UNITED STATES PATENT AND TRADEMARK OFFICE

APPLICATION NO.	FILING DATE	FIRST NAMED INVENTOR	ATTORNEY DOCKET NO.	CONFIRMATION NO.
10/501,276	07/09/2004	Johannes F de Boer	36115/US/2 - 475387-00016	3104
30873 7590 12/18/2006 DORSEY & WHITNEY LLP INTELLECTUAL PROPERTY DEPARTMENT 250 PARK AVENUE NEW YORK, NY 10177			EXAMINER DETSCHER, MARISSA	
			ART UNIT	PAPER NUMBER
			2877

Office Action Summary

DETAILED ACTION

FIG. 5

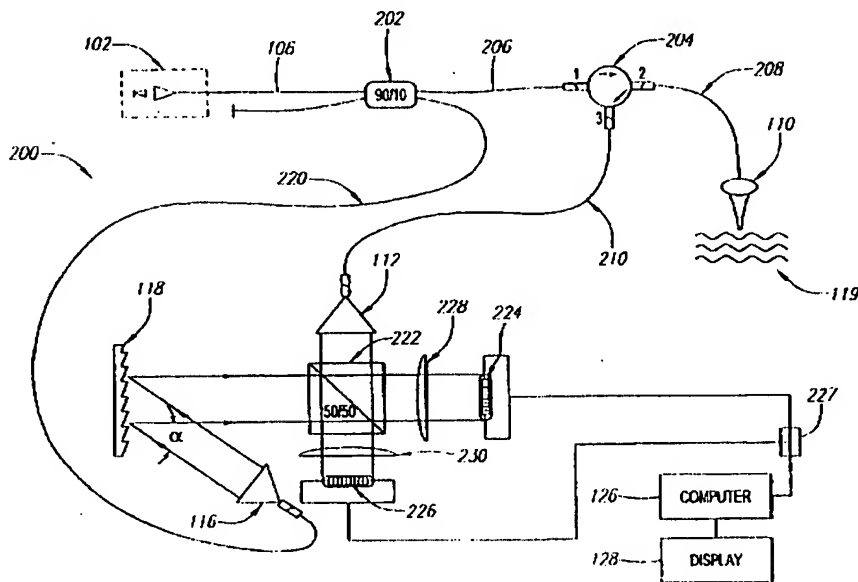
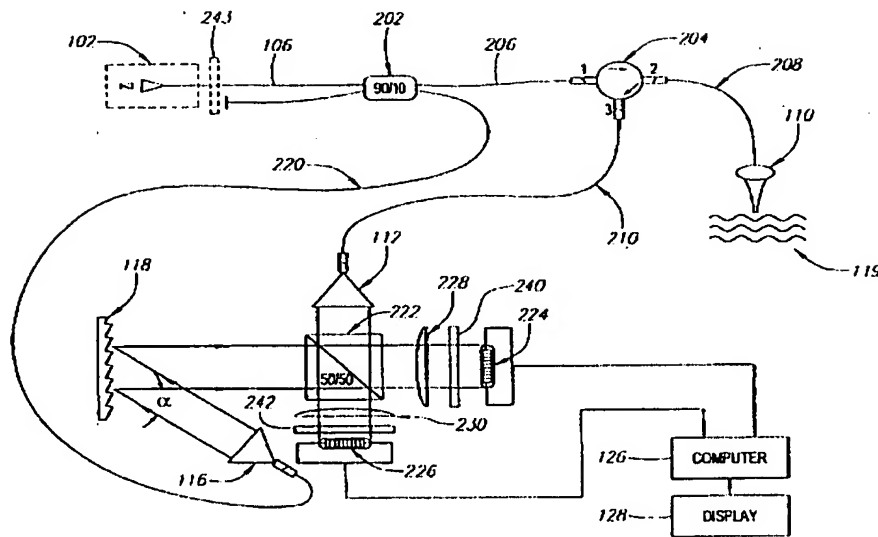
Regarding claims 103, 130, 159, 178, 186, 189, 205, 215, 216, 237, 303, and 306, Ostrovsky discloses an apparatus (Figure 5 below) and method for optical imaging, comprising:

receiving at least one first electro-magnetic radiation from a sample (119) and at least one second electro-magnetic radiation from a non-reflective reference (220);

Light is provided from a light source (102) to a 90/10 beamsplitter (202) through an optical fiber (106). 90% of the beam is sent to a sample (119) and 10% is sent through a reference (220). The sample light beam (i.e. the first electro-magnetic radiation) is sent to a circulator (204) to be sent to a sample (119), reflected therefrom, and sent to a 50/50 beamsplitter (222). The reference light beam (i.e. the second electro-magnetic radiation) is sent through an optical fiber (220) to the 50/50 beamsplitter. (column 10, lines 1-36) The optical fiber (220) represents a non-reflective reference.

separating spectrum (via 118) of at least one of the first electro-magnetic, the second electro-magnetic radiation and a combination of the first and second electro-magnetic radiation into frequency components; and

The reference light beam exits the fiber (220) goes through a collimator (116) and is directed onto a reflective diffraction grating (118). This separates the second electro-magnetic beam and sends it to the 50/50 beamsplitter (column 10, lines 36-44) enabling at least one detection of at least a portion of at least one of the frequency components using plurality of detectors (224, 226).

At the 50/50 beam splitter, the sample and reference beams are combined and sent to two photo detectors (224 and 226). (column 10, lines 45-53) Therefore, at least one of the first and second electro-magnetic radiations interfere with one another. The detectors may be tuned to detect light at different wavelength bands (column 11, lines 26-29), and, therefore, a detection of at least one frequency (i.e. wavelength) component is accomplished.

FIG. 7

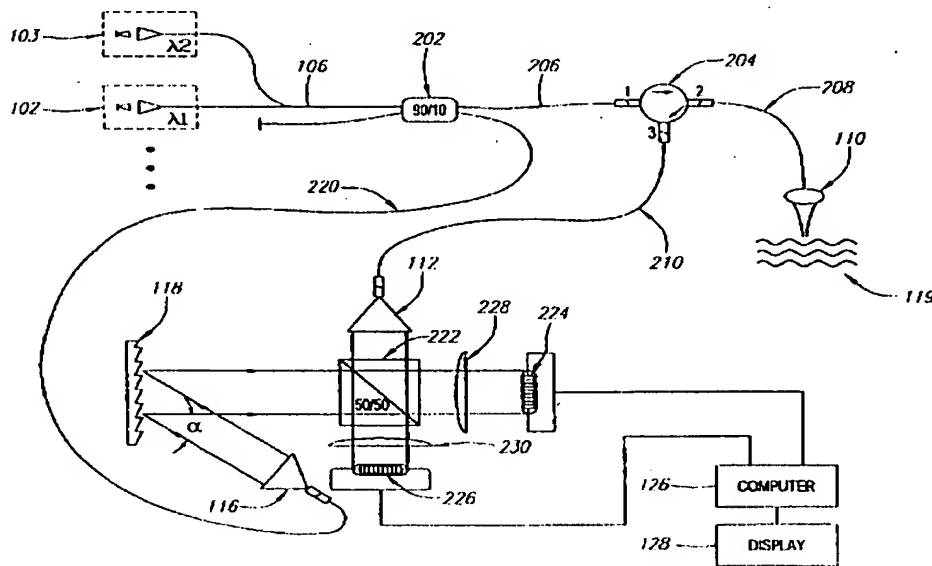
In yet another embodiment of figure 5, illustrated below in Figure 7, more than one light source (102, 103) can be provided. (column 11, line 66 to column 12, line 8) This second light

source (103) generates a third electro-magnetic radiation. Using the polarization detection embodiment of Figure 6, polarization modulators are positioned in the path of the combined first, second, and third electro-magnetic radiations.

As illustrated in figure 7 above, the light from the second source (103) generates a third electro-magnetic radiation. A splitter (202) separates the third electro-magnetic radiation into a fourth electromagnetic radiation directed to the reference and a fifth electro-magnetic radiation directed to a sample.

FIG. 16

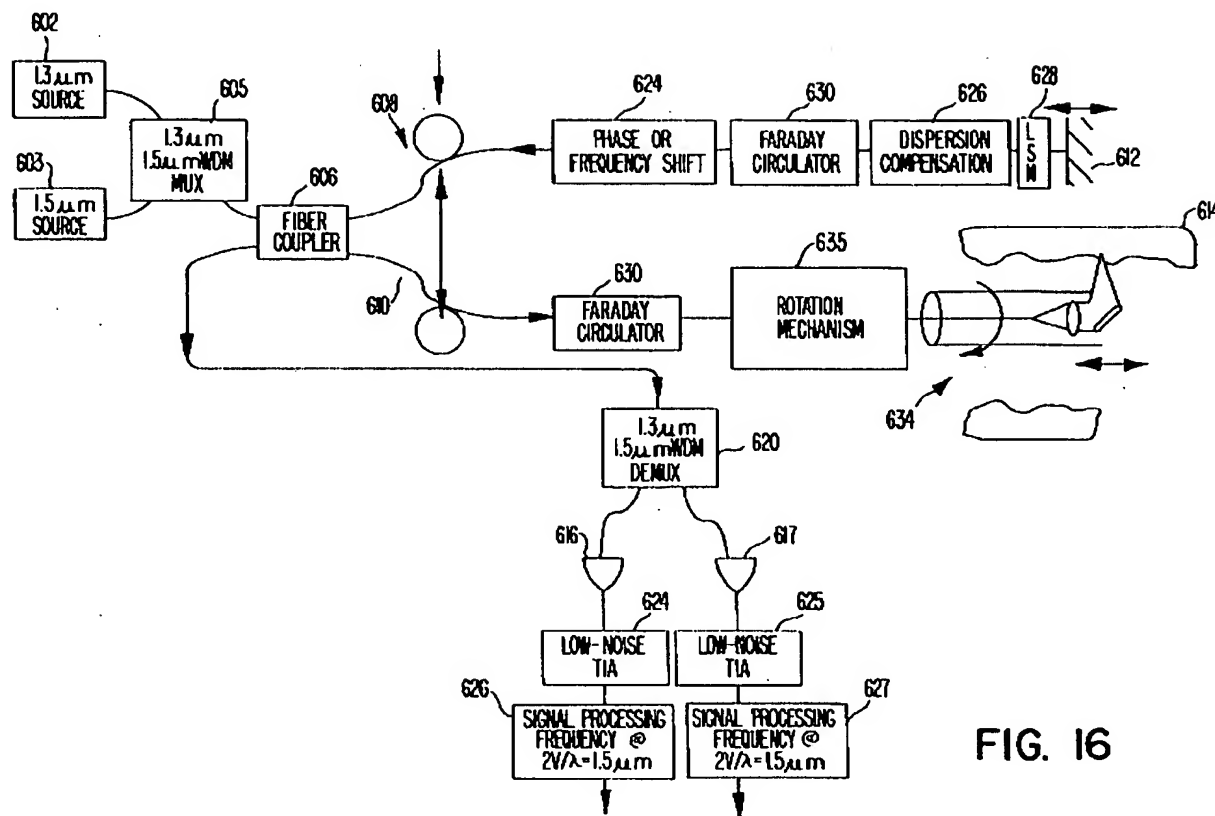
As to claim 159, Tearney discloses an apparatus for imaging (Figure 16 below) comprising:

Light emitted from two optical sources (602, 603) set at two different wavelengths is combined in a wavelength division multiplexer. The combined light is sent to an optical coupler (606). From the coupler, one beam (i.e. a first electro-magnetic radiation) is sent along a measurement arm (610) to an endoscopic unit (634) and the other (i.e. a second electro-magnetic radiation) is sent along a reference arm (608) to a reference reflector (612). Both beams are reflected from the reference reflector and a sample (614) and recombined in an optical coupler (606).

After the beams are recombined in the optical coupler, they reach a WDM demultiplexer (620). The demultiplexer separates the light back into the two different wavelengths of the two optical sources. This is also a separation of the spectrum of the combination of the first and second electro-magnetic radiations.

The signals from the demultiplexer are input into two detectors (616, 617), both of which detect a separate wavelength of light. The signals from the detectors are conditioned by a low noise transimpedance amplifier (624, 625) prior to being sent to two signal processing modules (626, 627). (column 16, lines 36-64) These signals are from the combined first and second electro-magnetic radiations. This configuration of the demultiplexing provides enhanced sensitivity, as there is detected shot noise from only one optical wavelength (column 17, lines 16-20). This is a reduction in noise of the signals.
